Subject: RE: 05533254 Jacktrees Road ,Cleator Moor, Moor Row, Cleator Moor, Cumberland, CA25 5NT
Date: Wednesday, 12 March 2025 at 13:27:55 Greenwich Mean Time
From: Stephen Jones
To: [REDACTED]
CC: [REDACTED]

Pre Development Enquiry - Jacktrees Road, Cleator Moor CA25 5NT – UU ref 05533254

Photo No. 0928 Photo 0910

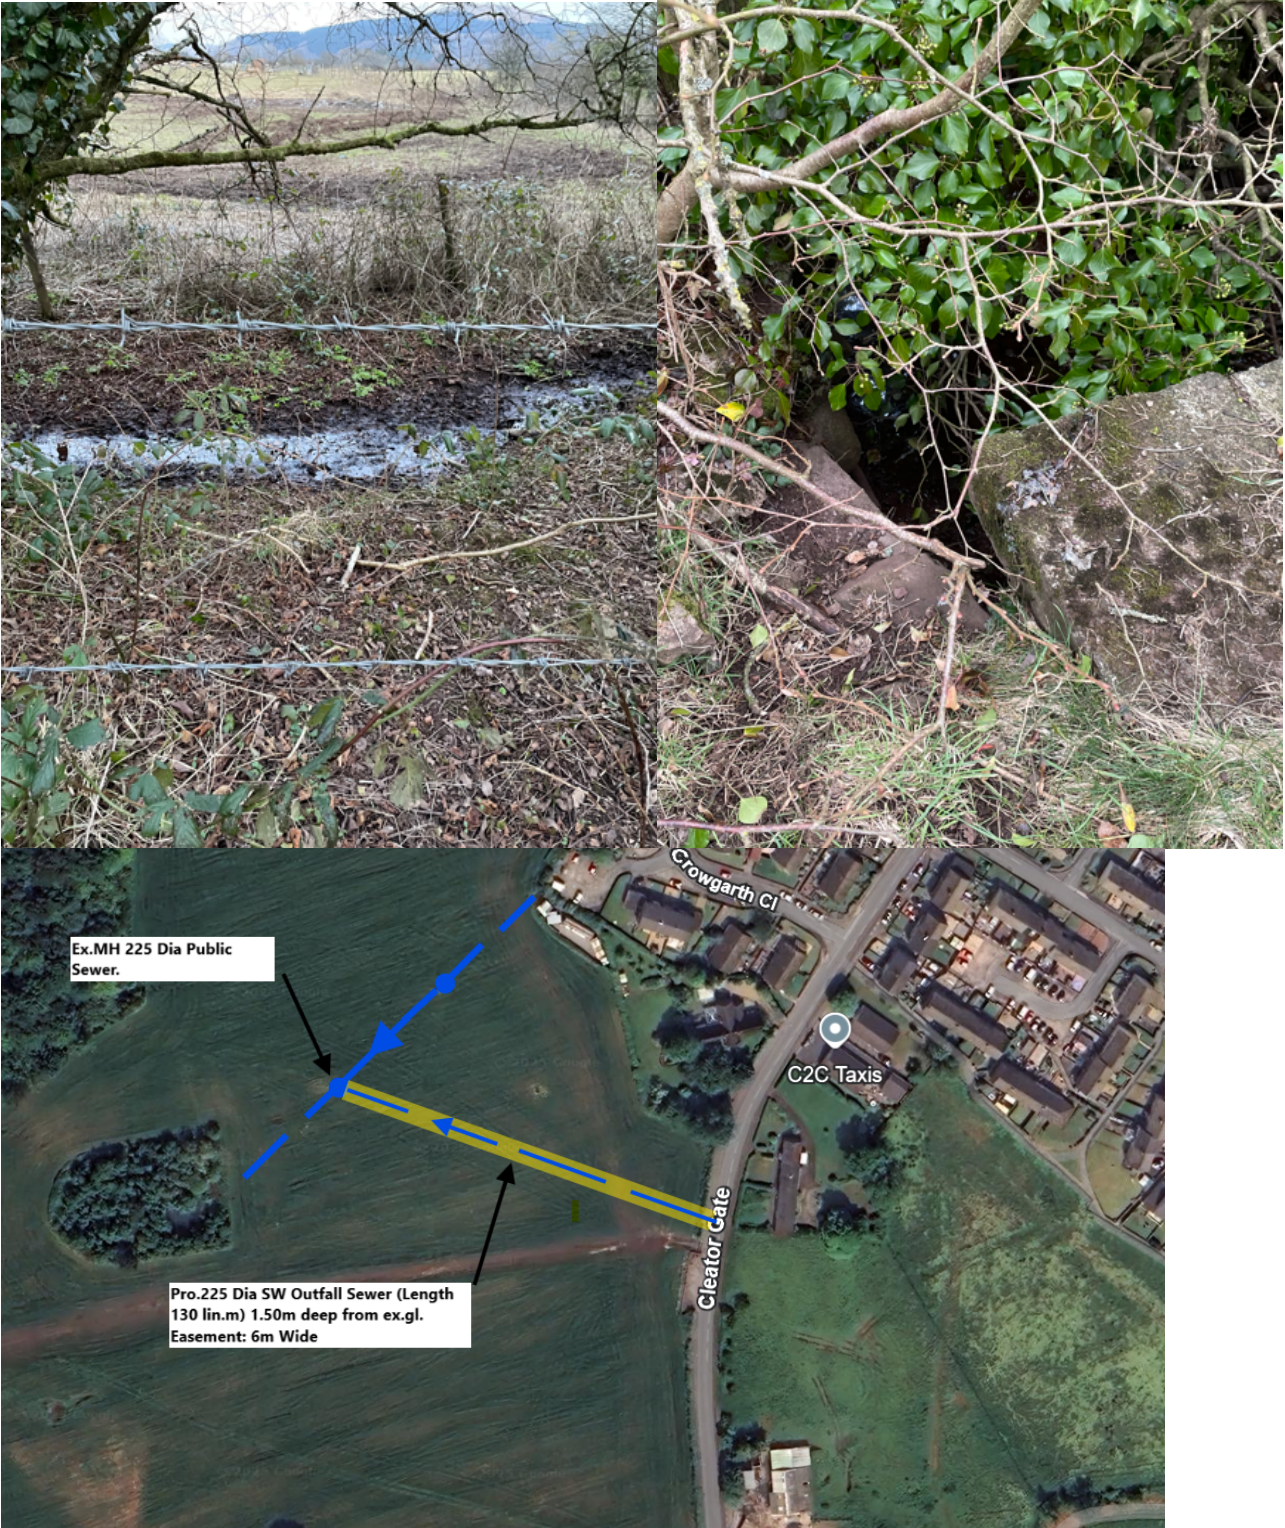
Please see screenshot showing the location and reference numbers of photos taken along the boundary/hedge line at the location of the water/ditchcourse you had identified. I will forward the photos under separate cover.

Photos 0928 & 0910 (see screenshot below) show the watercourse and the cover stone over the same to the location of the footpath. The watercourse can be best described as an overland route rather than a clearly defined ditchcourse suitable for discharging albeit restricted surface water flows from the housing development. Also, the watercourse is located on the farmland adjoining Donaldson Dairy's land, which we have had favourable discussions concerning an easement over their land (see screenshot below).

I would, therefore, propose the restricted surface water flows from the housing development (Phase 1 & 2) discharge by gravity sewer to the existing 225 Dia., gradient of 1/19 public sewer, which outfalls to the pond located within Donaldson Dairy's farmland. Please see attached Lidar survey (PDF) showing the topography of the Dairy's farmland, receiving Pond and ex. public sewer. Notably, there are 2 No manholes on the line of the public sewer located within the farmland that aren't shown on the sewer records.

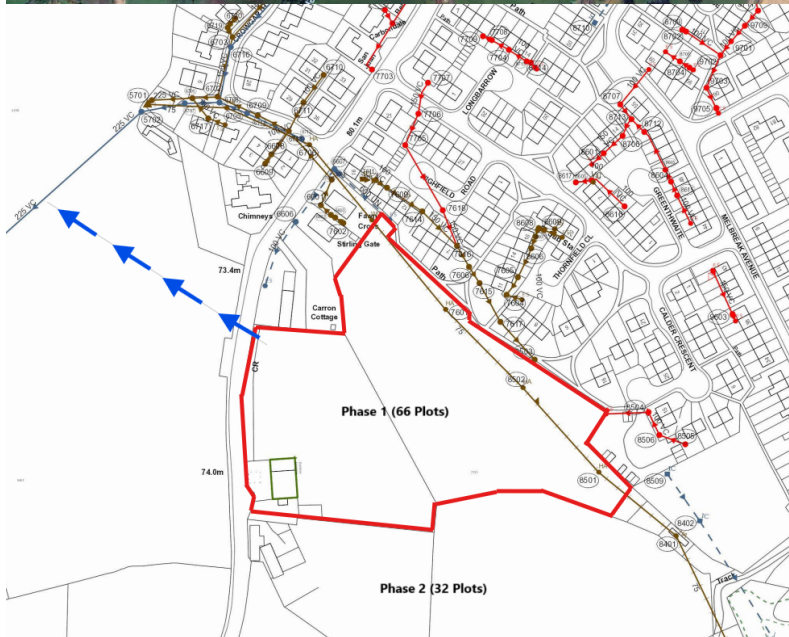
I have entered into discussions with the riparian owner of the parcels of land shown edged Purple (CU217582) and Yellow (CU97740) concerning obtaining their approval to construct the proposed surface water outfall sewer serving our development over their land to the R. Keekle.

I am having difficulty contacting the riparian owner of the land edged Green (CU95026) who no longer lives at the address registered on the 'Official copy of the register of title' for the land. We can't rule out the owner has passed away and there may be complication with the registered title of the land that could take a considerable time to resolve (see screenshot below &

I have had more favourable discussions with the riparian owner of the land edged Purple (CU217582) and believe I will obtain their approval to construct the surface water outfall to the POC located on the aforementioned existing 275 Dia. public sewer. Soakaways are not an option due to the CLAY strata underlying the site.

Thank you for detailing the issues with obtaining landowner permissions. To reach a watercourse. I accept a solution which only includes crossing the land marked in purple in your email is required, i.e. I accept the land boundaries marked in green and yellow are unlikely to be possible to cross.

There does appear to be a watercourse on the boundary between the purple and yellow areas, so a watercourse system of some kind may well be reachable without crossing the yellow or green boundaries. I have circled this red in the attached snippet. This is likely where the flows from our surface water sewer (which is mapped to outfall to natural ponds just north) will end up. So another option may be to discharge directly to the same natural ponds that our existing sewer discharges to. These options would need to be explored further, but ultimately if these are explored and properly discounted then I would be willing to accept a connection to public 225mm surface water sewer.
